ORANGE & COLONIAL HOTEL (REPLAT)

SUMMARY

Minor Subdivision Plat

ORANGE & COLONIAL HOTEL

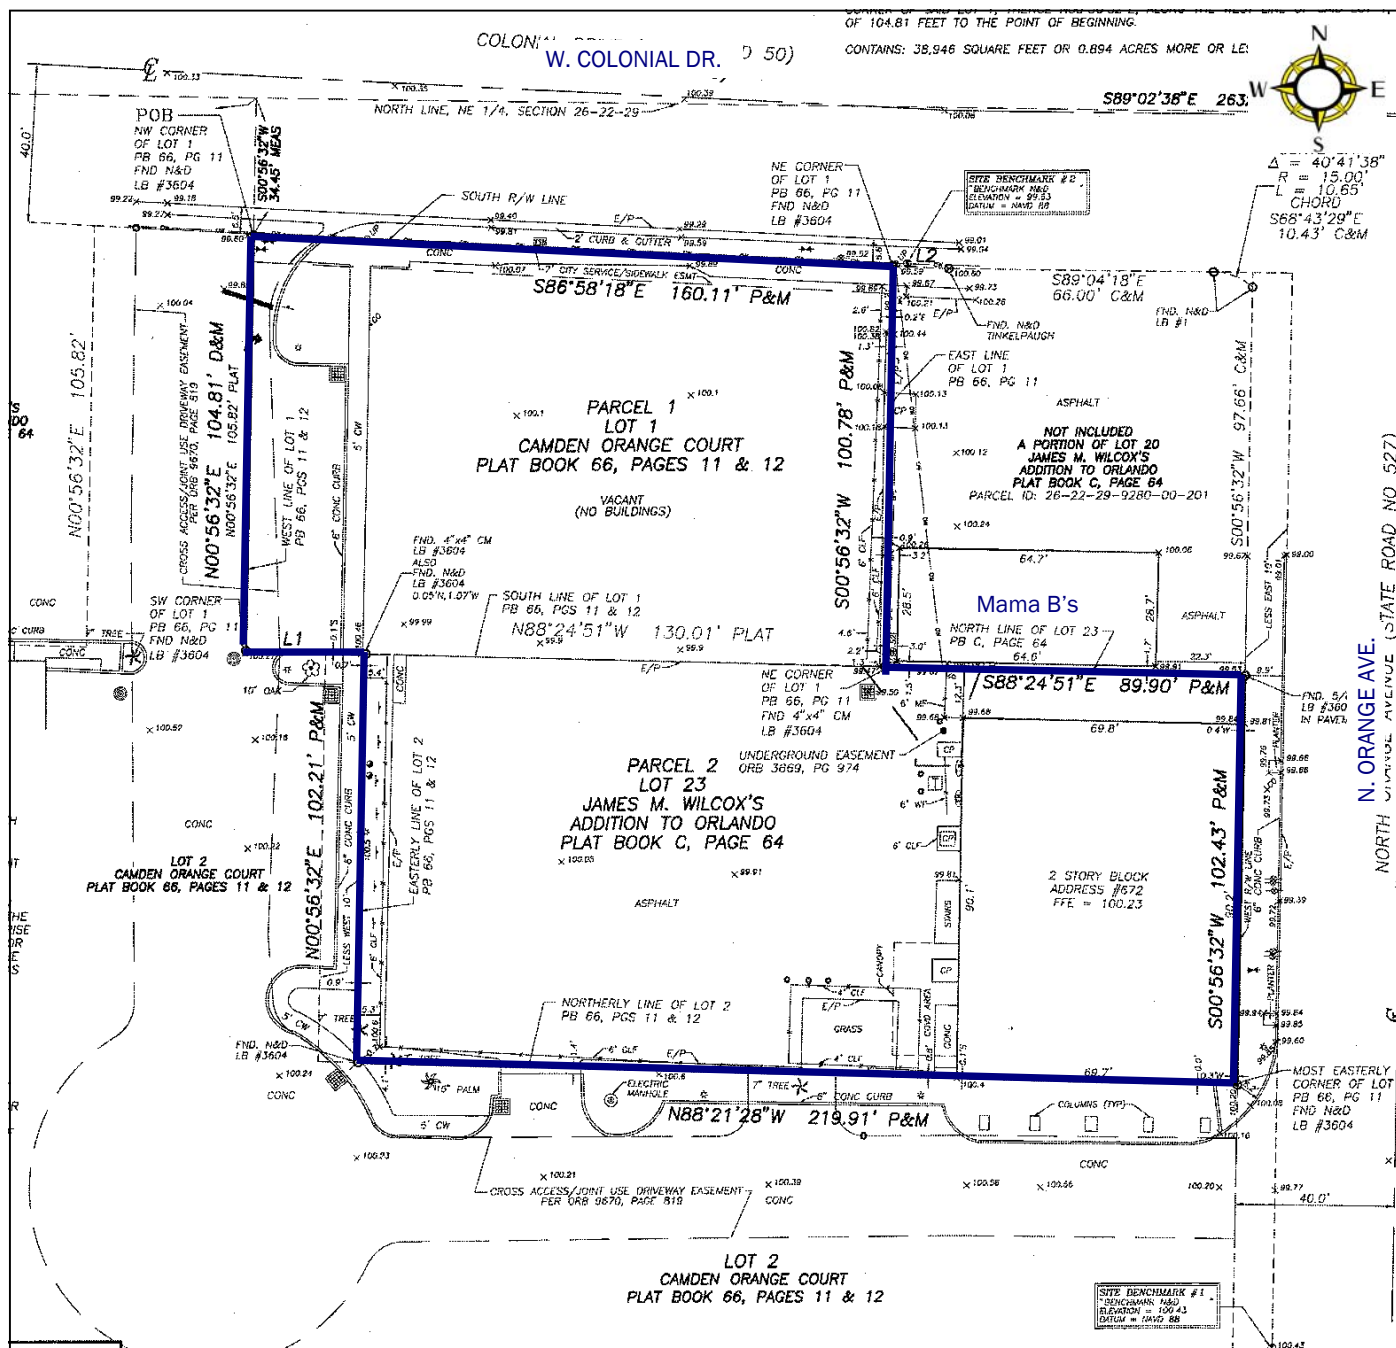
The proposed development will consist of a 135-room, 8 story hotel with 4,000 sq. ft. of ground floor commercial space facing W. Colonial Dr., and a 146 space integrated parking garage. Several existing easements are shown on the face of the plat. Staff is requesting that at least two (2) additional City Services/Sidewalk Easements be provided along W. Colonial Dr. and N. Orange Ave. to be consistent with the adopted Master Plan.

1. Plat Face Changes: In addition to the changes required on the plat, the following is a list of additional requirements:
 - a) Changes to the face of the plat (a copy has already been returned to the surveyor).

2. Stormwater - The Streets and Stormwater Division did not see an area on the Replat outlined for stormwater treatment. On-site stormwater treatment is required, and should be laid out early in the process. Can we expect the site plans to identify the storm water treatment area?

4. Sidewalk Easement - A 7-foot wide City Service/Sidewalk Easement shall be shown on the face of the plat along the north side of the property line adjacent to Colonial Drive and a 4-foot wide City Service/Sidewalk Easement shall be shown on the face of the plat along the east side of the property line adjacent to Orange Avenue, consistent with the recorded Camden Orange Court plat for Lots 1 and 2.
